# DARLING DRIVE, HAY STREET TO HARBOURSIDE ROUNDABOUT, DARLING HARBOUR

## PRELIMINARY DESIGN ROAD SAFETY AUDIT

**Report No** F0001-AA004399-11-02-03-AAR-02

# DARLING HARBOUR LIVE

**Table 2 Road safety audit findings**

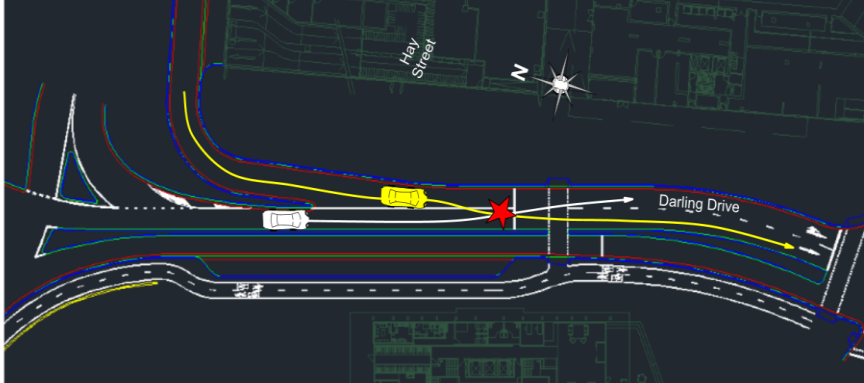
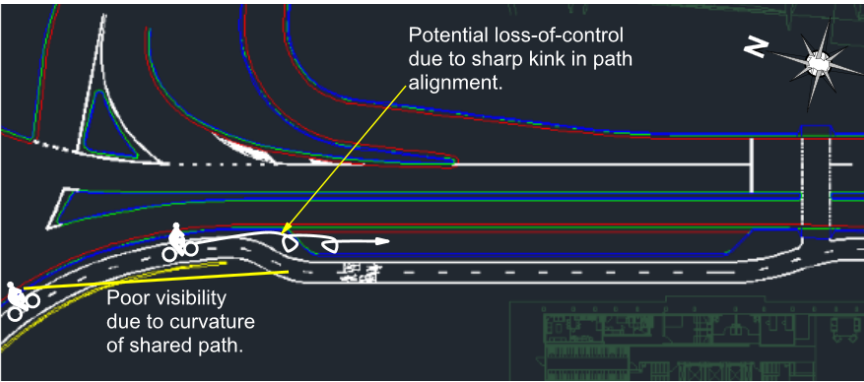
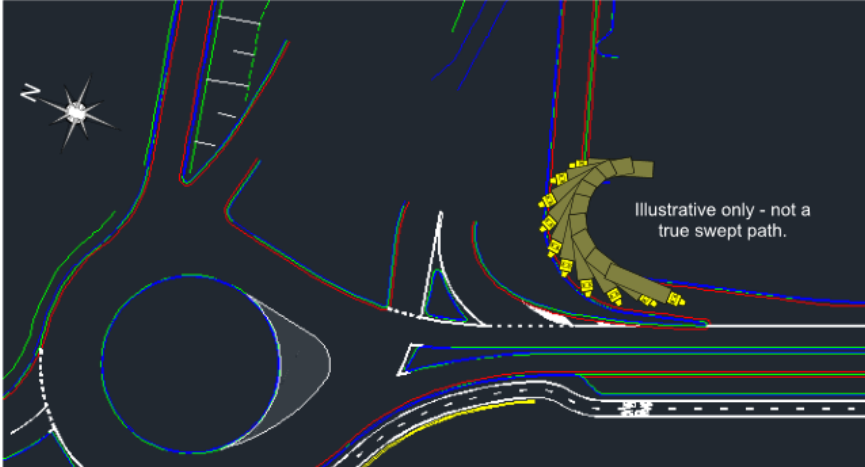
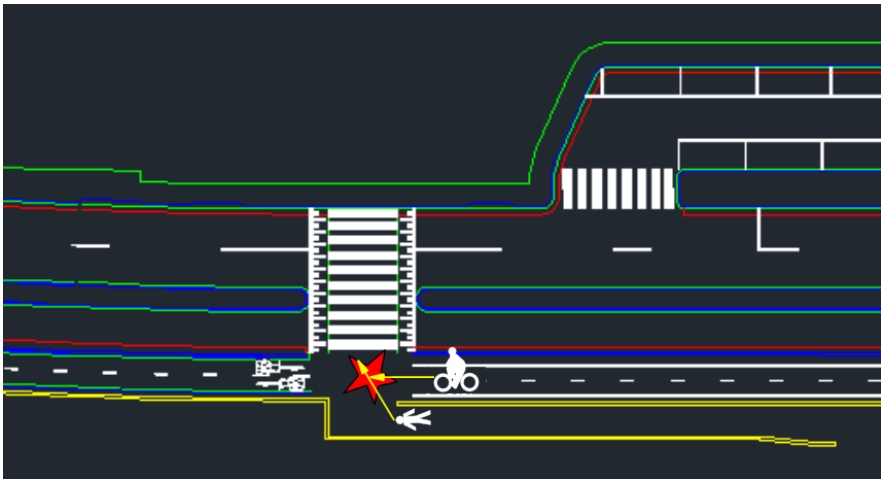
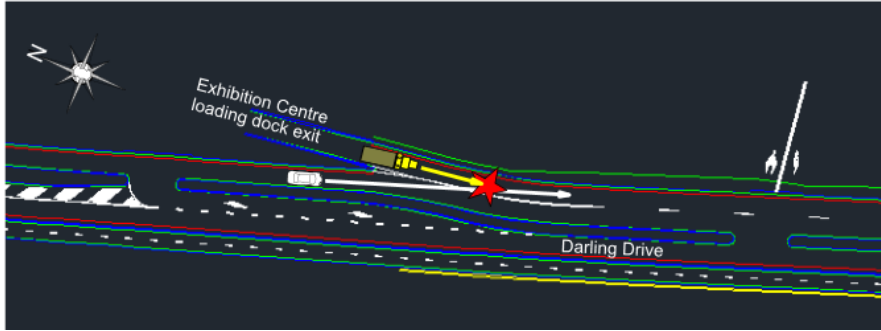
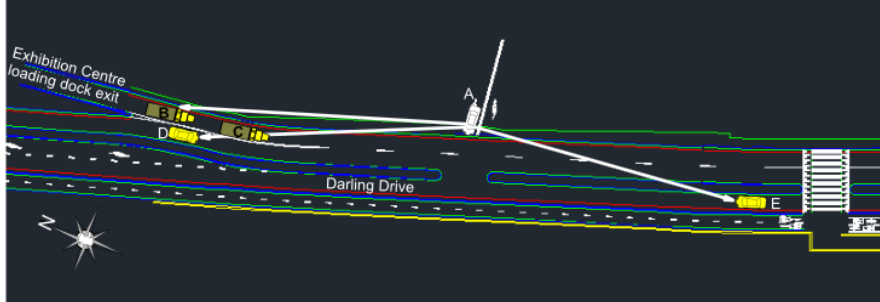
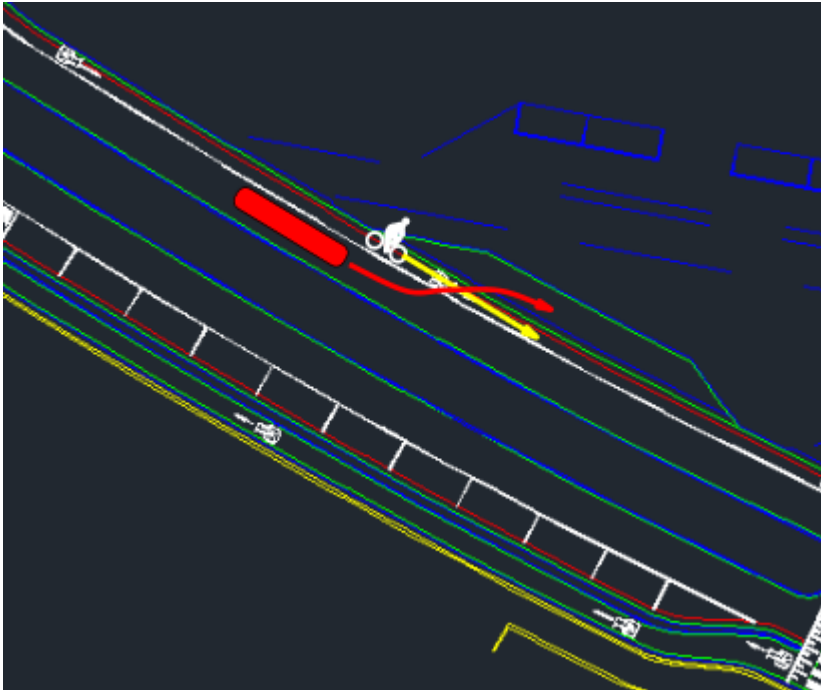
No	Location	Safety findings	Risk rating
1	Darling Drive/ Hay Street intersection.	<p>At the southern entrance to the <i>Haymarket Precinct SW Plot</i>, the section of Hay Street leading to Darling Drive is very short, which could result in westbound traffic queuing back into the development. Additionally, eastbound (inbound) traffic may queue into the control area of the Darling Drive/ Hay Street intersection due to potential delays at gates in the driveway. This may lead to queued vehicles becoming trapped in the control area of the intersection (see below).</p>  <p><i>Above: Risk of queue spillback from Haymarket Precinct SW Plot to the control area of the Darling Drive/ Hay Street intersection.</i></p>	Low
2	Hay Street.	<p>At the interface between Darling Drive and Hay Street, the eastbound departure lane in Hay Street is narrow. The swept path envelope of a right-turning vehicle from Darling Drive may encroach over the centreline of Hay Street and increase <i>head-on</i> crash risk. This is also an issue for the southbound left turn movement from Darling Drive (shown below).</p>  <p><i>Above: Head-on crash conflict due to limited swept path clearance for vehicles entering Hay Street.</i></p>	Medium

No	Location	Safety findings	Risk rating
3	Darling Drive/ Hay Street intersection.	<p>The following observation was made regarding a current issue at the Darling Drive/ Hay Street intersection which would also affect safety of drivers egressing from the <i>Haymarket Precinct SW Plot</i>.</p> <p>Vehicles turning left from Hay Street to Darling Drive (Car A) would not see the red left turn arrow aspect (at B) due to a tram blocking their view. This driver would only see the full green aspect at the signals at C. As such, there is a potential tram-vehicle conflict as the left turning vehicle may believe they have right-of-way.</p>  <p><b>Above:</b> The left-turn arrow aspects from the signals at B would be obscured by passing trams. Egressing vehicles would only be able to see the full green aspect at C.</p>	Medium
4	Darling Drive northbound lane approaching Hay Street.	<p>On the northbound bicycle lane along Darling Drive to the south of Hay Street, there is potential for cyclists to be impacted by opened doors and mirrors of vehicles parked in the parking bays. Furthermore, drivers manoeuvring into car spots would present further risk of vehicle-cyclist collisions.</p>  <p><b>Above:</b> Vehicle-bicycle crash conflicts along the western side of Darling Drive to the south of Hay Street.</p>	Medium

No	Location	Safety findings	Risk rating
5	New signalised midblock crossing on Darling Drive between Hay Street and Pier Street.	<p>The existing midblock between the Pier Street roundabout and the Hay Street signals is approximately 140m long. The proposed signalised midblock crossing will create four short midblocks including (i) northbound carriageway between Pier Street and the crossing, (ii) northbound carriageway between the crossing and Hay Street, (iii) southbound carriageway between Hay Street and the crossing, and (iv) southbound carriageway between the crossing and Pier Street.</p> <p>There is a risk of queues from either of these three control points (ie. Pier Street roundabout, midblock signalised crossing, and Hay Street intersection) spilling back and straddling the upstream facility. In the case of upstream intersections, queued vehicles may become stranded in the control area of the intersection. Alternatively, the departure speeds may be significantly reduced such that a rear-end conflict arises between a vehicle departing an intersection (and hence accelerating) and a slowed or stationary vehicle on the departure side of the intersection.</p> <p>In the northbound direction, if queues spill back across the tram line, this could result in a potentially catastrophic crash between a tram and a queued vehicle.</p> <p>The added problem is that as a non-signalised facility, the Pier Street roundabout cannot be coordinated with the signalised midblock crossing or Hay Street intersection which would be both signal controlled and presumably SCATS linked.</p>	Medium.

6	Darling Drive between Hay Street and Pier Street.	<p>Pedestrians waiting to cross Darling Drive from the western side of the proposed signalised midblock crossing between Hay Street and Pier Street may be vulnerable to impacts from cyclists on the shared path.</p>  <p><b>Above:</b> Bicycle-pedestrian crash conflicts at taxi rank and signalised midblock crossing.</p>	High
7	Taxi rank on the western side of Darling Drive – south of the Pier Street roundabout	<p>The taxi rank on the western side of Darling Drive also presents a bicycle-pedestrian crash conflict. Passengers boarding/ alighting from buses will be at risk of impacts from cyclists on the shared path (see diagram in item 6).</p>	High

No	Location	Safety findings	Risk rating
8	Southbound carriageway of Darling Drive between Pier Street and Hay Street.	<p>There is a possible weaving crash conflict in the midblock between Pier Street and Hay Street. Vehicles travelling in the southbound <i>through</i> lane of Darling Drive and intending to turn left into Hay Street will need to move from right to left. Vehicles egressing from the <i>Exhibition Place loop road</i> and intending to turn right into Ultimo Road would need to move from the left to the right. These weaving conflicts would occur over a 100-120m length of road (depending on the extent of queuing in the southbound approach to Hay Street). These crash conflicts are also likely to occur near the proposed signalised midblock pedestrian crossing, which creates additional risks of pedestrian-vehicle impacts.</p>  <p><b>Above:</b> Potential weaving crash conflict.</p>	Medium

9	Bus stop on Darling Drive between Pier Street and Hay Street	<p>To accommodate the bus stop, there is a kink in the alignment of the shared path. On the southbound approach, this kink closely follows a corner, which could lead to <i>loss-of-control</i> events for cyclists.</p> <p>Furthermore, southbound cyclists may have poor visibility to the bus stop due to the curvature of the road and possible retaining walls. This could increase the risks of bicycle-pedestrian impacts.</p>  <p><b>Above:</b> Safety issues for cyclists at the sharp change in shared path alignment, and potential blind corner.</p>	High

No	Location	Safety findings	Designer's response
1	Darling Drive/ Hay Street intersection.	At the southern entrance to the <i>Haymarket Precinct SW Plot</i> , the section of Hay Street leading to Darling Drive is very short, which could result in westbound traffic queuing back into the development. Additionally, eastbound (inbound) traffic may queue into the control area of the Darling Drive/ Hay Street intersection due to potential delays at gates in the driveway. This may lead to queued vehicles becoming trapped in the control area of the intersection	30m of vehicle queue containment has been provided between the control point and the property boundary, with a further 8m provided between the property boundaries to Hay Street. Should additional queue containment be required, this will be addressed during the detailed design stage, to ensure that queue containment is contained within the property boundary and access road.

2	Hay Street.	At the interface between Darling Drive and Hay Street, the eastbound departure lane in Hay Street is narrow. The swept path envelope of a right-turning vehicle from Darling Drive may encroach over the centreline of Hay Street and increase <i>head-on</i> crash risk. This is also an issue for the southbound left turn movement from Darling Drive	The width of the access road provided to the SW plot car park is 6.0m. If required, design changes to the road width will be made during the detailed design stage, and vehicle swept path analysis will be undertaken to confirm sufficient road width, to reduce risk of head-on crashes. Vehicle classification movements into the SW development are limited.

No	Location	Safety findings	Designer's response
3	Darling Drive/ Hay Street intersection.	<p>The following observation was made regarding a current issue at the Darling Drive/ Hay Street intersection which would also affect safety of drivers egressing from the <i>Haymarket Precinct SW Plot</i>.</p> <p>Vehicles turning left from Hay Street to Darling Drive (Car A) would not see the red left turn arrow aspect (at B) due to a tram blocking their view. This driver would only see the full green aspect at the signals at C. As such, there is a potential tram-vehicle conflict as the left turning vehicle may believe they have right-of-way.</p>	<p>This intersection currently operates in this fashion with the exit from the existing car park. There is effectively no change proposed for this intersection from what currently operates.</p> <p>Changes will be required to the existing signals on the junction of Darling Drive and Hay Street, to accommodate the Haymarket development. Visibility to traffic signals for traffic egressing from Hay Street will be considered during the design of the traffic signals for this junction.</p>

4	New signalised midblock crossing on Darling Drive between Hay Street and Pier Street.	<p>The existing midblock between the Pier Street roundabout and the Hay Street signals is approximately 140m long. The proposed signalised midblock crossing will create four short midblocks including (i) northbound carriageway between Pier Street and the crossing, (ii) northbound carriageway between the crossing and Hay Street, (iii) southbound carriageway between Hay Street and the crossing, and (iv) southbound carriageway between the crossing and Pier Street.</p> <p>There is a risk of queues from either of these three control points (i.e. Pier Street roundabout, midblock signalised crossing, and Hay Street intersection) spilling back and straddling the upstream facility. In the case of upstream intersections, queued vehicles may become stranded in the control area of the intersection. Alternatively, the departure speeds may be significantly reduced such that a rear-end conflict arises between a vehicle departing an intersection (and hence accelerating) and a slowed or stationary vehicle on the departure side of the intersection.</p> <p>In the northbound direction, if queues spill back across the tram line, this could result in a potentially catastrophic crash between a tram and a queued vehicle.</p> <p>The added problem is that as a non-signalised facility, the Pier Street roundabout cannot be coordinated with the signalised midblock crossing or Hay Street intersection which would be both signal controlled and presumably SCATS linked.</p>	<p>The proposed signalised pedestrian crossing will be assessed during the detailed design stage to ensure that the signal phasings do not disrupt the operation of adjacent intersections.</p> <p>NSW road rule "128 Entering blocked intersections", states that A driver must not enter an intersection if the driver cannot drive through the intersection because the intersection, or a road beyond the intersection, is blocked.</p>

No	Location	Safety findings	Designer's response
5	Darling Drive between Hay Street and Pier Street.	Pedestrians waiting to cross Darling Drive from the western side of the proposed signalised midblock crossing between Hay Street and Pier Street may be vulnerable to impacts from cyclists on the shared path.	The crossing will be designed to ensure adequate sight lines are maintained for pedestrians, cyclists and motorists. Consideration will be given to the provision of adequate standing room for pedestrians waiting to cross the proposed signalized mid-block crossing, to protect them from impacts from cyclists, during the detailed design stage.
6	Loading Zone on the western side of Darling Drive – south of the Pier Street roundabout	The truck loading / refuse collection zone on the western side of Darling Drive also presents a bicycle-pedestrian crash conflict. People boarding/ alighting from vehicles in this zone will be at risk of impacts from cyclists on the shared path	This zone is intended for use by refuse vehicles collecting refuse from the student accommodation plot, seasonal loading/unloading into the student accommodation by students and taxi drop-off to this plot. It is not anticipated that a high turnover of vehicles movements will occur in this zone, on a daily basis.  A 1.0m clearance zone has been provided between the face of kerb of the loading zone along Darling Drive, opposite the proposed student accommodation plot, and the edge of the proposed shared cycle way, in accordance with design guidelines to protect cyclists from the impact of vehicle door openings, and people alighting from vehicles.

7	Southbound carriageway of Darling Drive between Pier Street and Hay Street.	There is a possible weaving crash conflict in the midblock between Pier Street and Hay Street. Vehicles travelling in the southbound <i>through</i> lane of Darling Drive and intending to turn left into Hay Street will need to move from right to left. Vehicles egressing from the <i>Exhibition Place loop road</i> and intending to turn right into Ultimo Road would need to move from the left to the right. These weaving conflicts would occur over a 100-120m length of road (depending on the extent of queuing in the southbound approach to Hay Street). These crash conflicts are also likely to occur near the proposed signalised midblock pedestrian crossing, which creates additional risks of pedestrian-vehicle impacts.	The location of the crossing has been assessed for weaving and merging movements for through traffic on Darling Drive west of the crossing intending to turn left at Hay Street access lane.  Vehicles exiting from Exhibition Place have approximately 335m to change lanes prior to the junction of Ultimo Road with Darling Drive. Only vehicles requiring access to the SW residential plot will require changing lanes to gain access to Hay Street, and there is approximately 88m of travel lane available to undertake this movement. Drivers making this movement will be predominately residents aware of this movement from continued use.

No	Location	Safety findings	Designer's response
8	Loading Zone on Darling Drive between Pier Street and Hay Street	To accommodate the loading zone, there is a kink in the alignment of the shared path. On the southbound approach, this kink closely follows a corner, which could lead to <i>loss-of-control</i> events for cyclists.  Furthermore, southbound cyclists may have poor visibility to the loading zone due to the curvature of the road and possible retaining walls. This could increase the risks of bicycle-pedestrian impacts.	The kink in the shared cycle way alignment will be addressed in the detailed design stage.
9	Exhibition Place loop road.	There is a potential vertical clearance risk along the proposed egress point from the <i>Exhibition Place loop road</i> . This is due to the westbound off-ramp from Pier Street.	Vertical clearance for vehicles anticipated to use the Exhibition Place loop road has been assessed, and can be accommodated.  This area is currently used by semi-trailers to allow access to / from the entertainment centre.

**Figure1:** Revised Theatre layout design

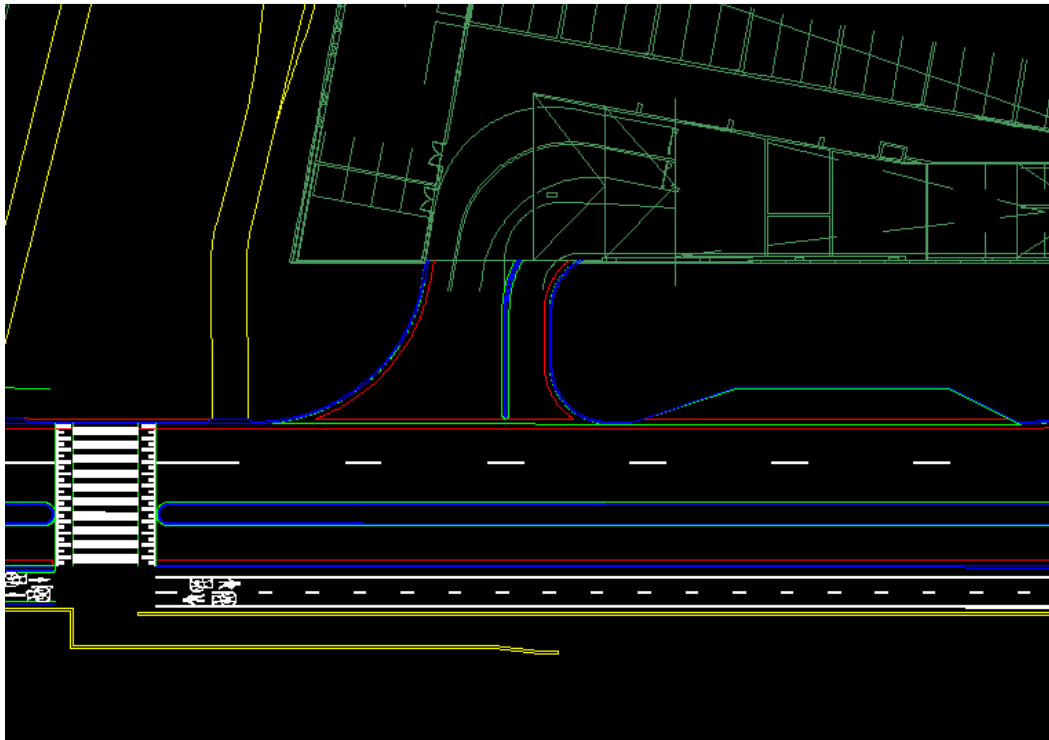
Since the road safety audit was undertaken, there has been a design change in the vicinity of the proposed Theatre car park access and egress. Previously, access for vehicles entering and exiting the Theatre car park, was provided on Exhibition Place. There was a proposed taxi holing zone to the west of the Theatre building, linked to Darling Drive. The pedestrian crossing linking Tumbalong Place and the light rail stop was proposed as either a zebra crossing or a staggered crossing.

Following the change to the Theatre building, access and egress will now be provided to the Theatre car park from Darling Drive. The taxi holing area has been replaced by an indented bus stop and the proposed pedestrian crossing is now proposed as a signalised crossing. Please see Figure 1 below:

We have now reviewed the left-in-left-out access/egress associated with the Theatre car park. We regard this to be a similar set of circumstances as the previously proposed taxi rank as the taxi rank is essentially a left-in-left-out arrangement. As per the audit report we had no issue with the taxi rank. As such, we also have no issue with the current proposal to have a left-in-left-out arrangement for the Theatre car park.
